STAMP MOLD 788 SAFETY BUTTON

Back inserts for XP-100 safety button

MOLD ASSEMBLY		RD CAV.	4	TYPE	INJECTION
		CUST.	REMINGTON	PROD.	SAFETY BUTTON
		PRESS	65 H100 MINIJECTOR		
SCALE	DATE	DR	LR	APP.	
	7-23-65	W/P			
J. G. TILP, INC.				JOB NO.	
UNION, N. J.				6982

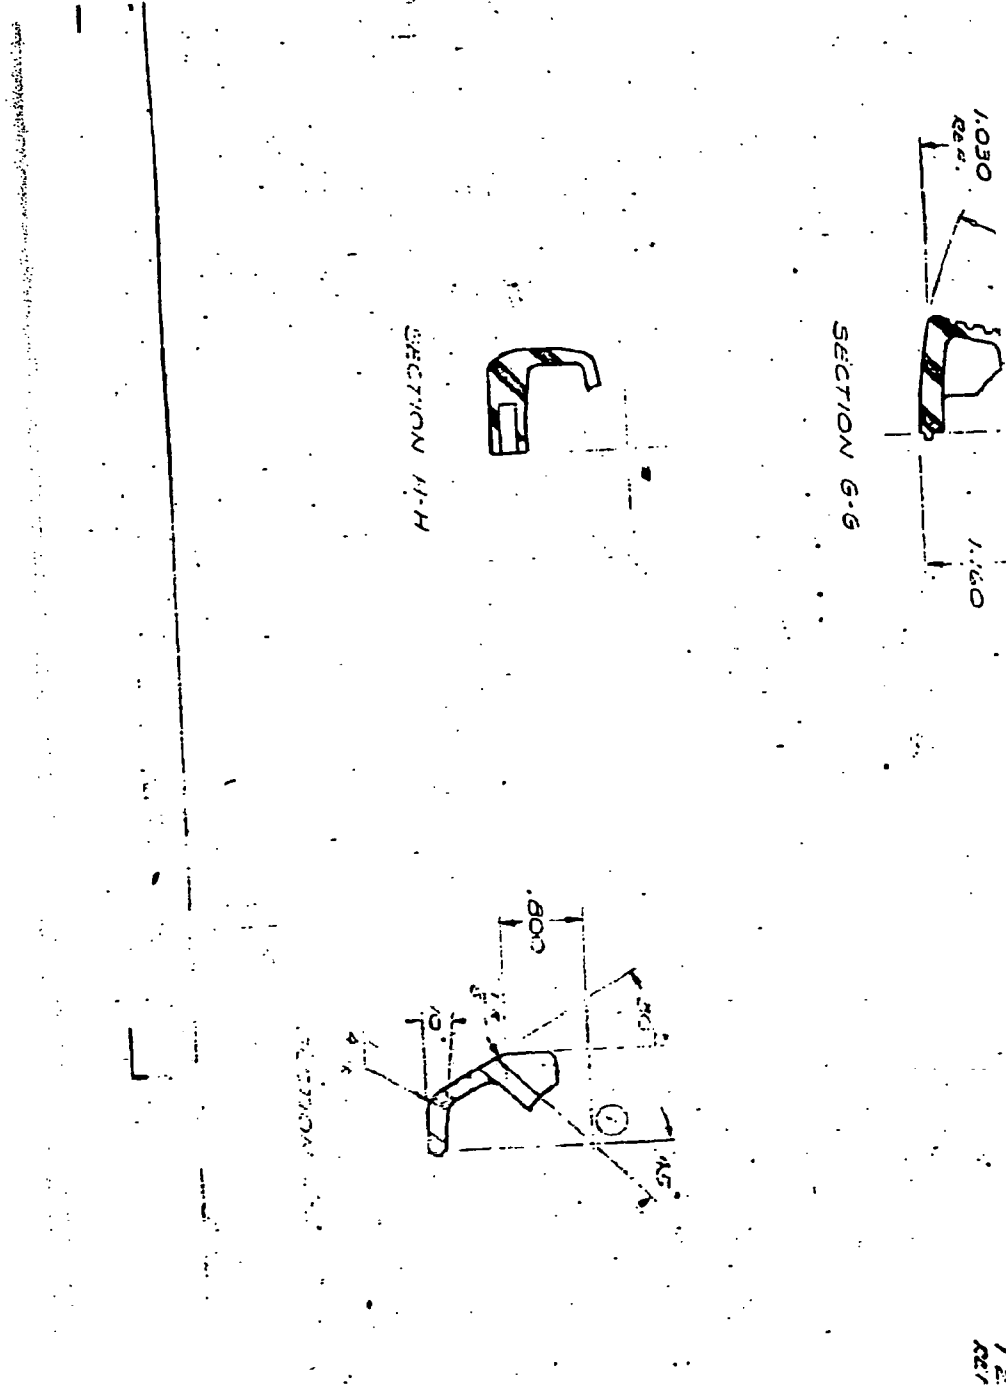
NOTE
CHECK GATE POSITION
ON PART. DNG. MUST BE ON
CORRECT SIDE.

NOTE (2) NEW CORES TO FIT INTERCHANGEABLE
WITH OLD CORES NEW SIZE ON WIDTH OF
LUGS ONLY WAS .055-860 NEW SIZE .080-075
JOB # 4460

MOLD ASSEMBLY		NO. CAV.	4	TYPE	INJECTION
		CUST.	REMINGTON	PROD.	SAFETY BUTTON
		PRESS	65 H/100 MINISECTOR		
SCALE	DATE	DR.	LA.	APP.	
	7-23-65	2/12			
J. G. TILP, INC.				JOB NO.	
UNION, N. J.				6982

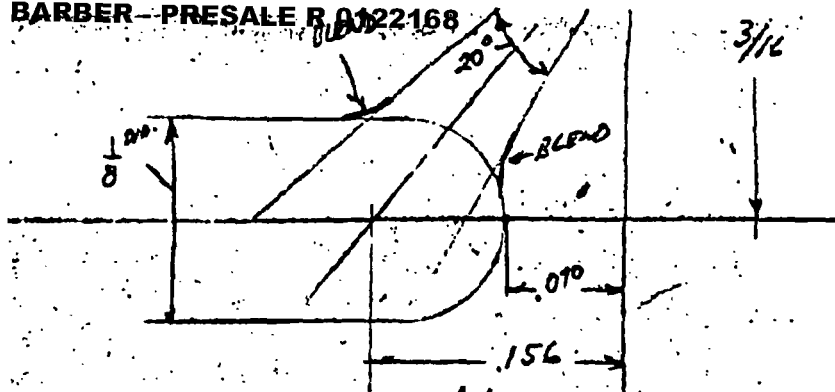
NOTE
CHECK GATE POSITION
ON PART. DNG. MUST BE ON
CORRECT SIDE.

NOTE (2) NEW CORES TO FIT INTERCHANGEABLE
WITH OLD CORES NEW SIZE ON WIDTH OF
CORES ONLY WAS .035-.060 NEW SIZE .080-.075
JOB # 4460

Back inserts for XP-100 safety button
